APPLICATION NO.	FILING DATE	FIRST NAMED INVENTOR	ATTORNEY DOCKET NO.	CONFIRMATION NO.
09/990,273	11/23/2001	Chun-Yang Hsiao	MR2707-3	2404
4586	7590	02/16/2006	EXAMINER	
ROSENBERG, KLEIN & LEE 3458 ELLICOTT CENTER DRIVE-SUITE 101 ELLICOTT CITY, MD 21043			KIM, DAVID S	
			ART UNIT	PAPER NUMBER
			2633

<b>Advisory Action</b> <b>Before the Filing of an Appeal Brief</b>	Application No. 09/990,273	Applicant(s) HSIAO ET AL.	
	Examiner David S. Kim	Art Unit 2633

Fig. 5(B)

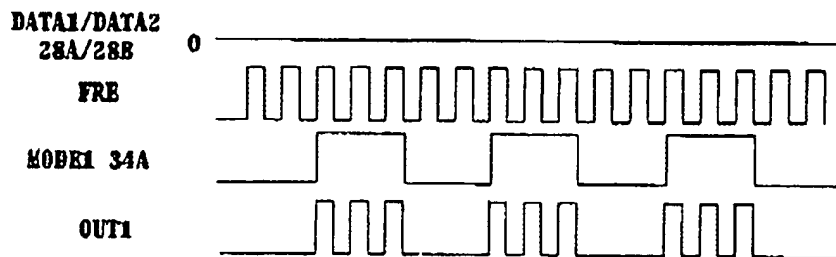
On p. 8, the first full paragraph makes references to features that no longer appear in Fig. 5(B):

- select control signal MODE2 34B
- carrier signal output port OUT2

As a simple remedy, Examiner respectfully suggest removing references to these features.

Fig. 5(C)

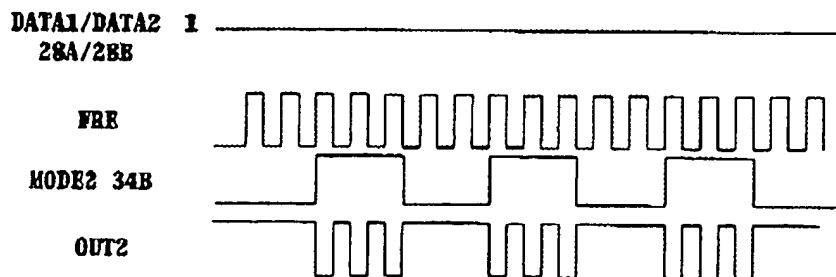
Additionally, on p. 8, the first full paragraph also makes references to features that no longer appear in Fig. 5(C):

- select control signal MODE1 34A
- carrier signal output port OUT1

As a simple remedy, Examiner respectfully suggest removing references to these features.
